**PROJECT:** Grand Junction VAMC  
PM&RS/PC  
Project VA259-12-C-0188

**ADDENDUM  
NO. 001**

**DATE:** February 27, 2015

Project Title  
GRAND JUNCTION VAMC  
PM & RS PROSTHETICS CENTER - BUILDING 38

Sketch Number  
S-503A-SK-2

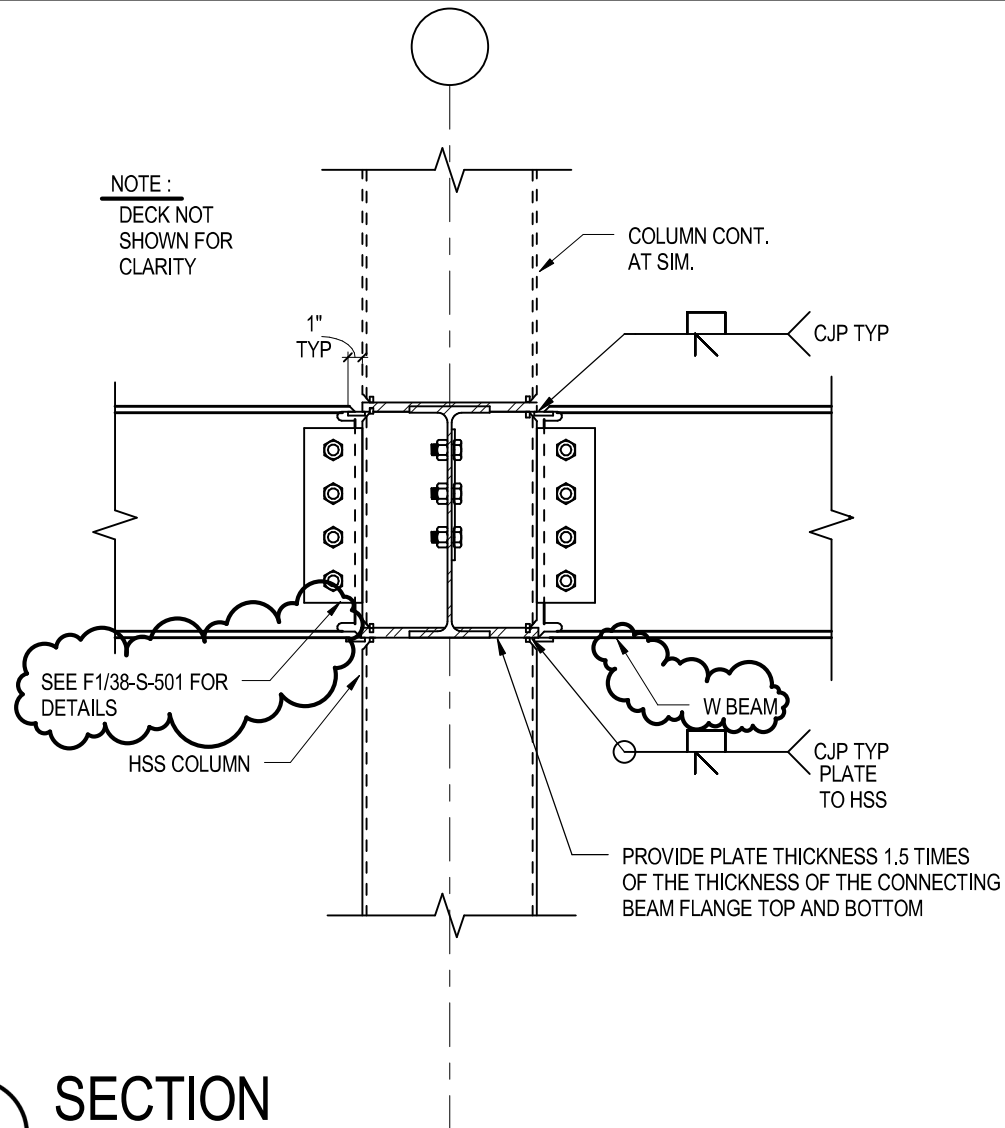
- Sheet 38-SF-101A
  - Change columns size at F-1.9, DA-1.9, and DC-1.9 to HSS12X6X3/8.
  - Change columns at size F-1.6, DA-D1, DB-D1, DC-D1, DE-D1, DF-D1, and DG-D1 to HSS12X4x3/8
- Sheet 38-SF-102A
  - Revise framing as shown on sketch SF-102A-SK-1.
  - Add full depth connection plate symbol at the beams framing into the W18x76 beam spanning from grids DC-1.9 to DG-1.9 as shown on sketch SF-102A-SK-1.
  - Add detail references as shown on sketch SF-102A-SK-1.
- Sheet 38-S-503A
  - Revise detail F3 as shown on sketch S-503A-SK-1.
  - Add detail D3 as shown on sketch S-503A-SK-2.

**D3** SECTION  
1" = 1'-0"
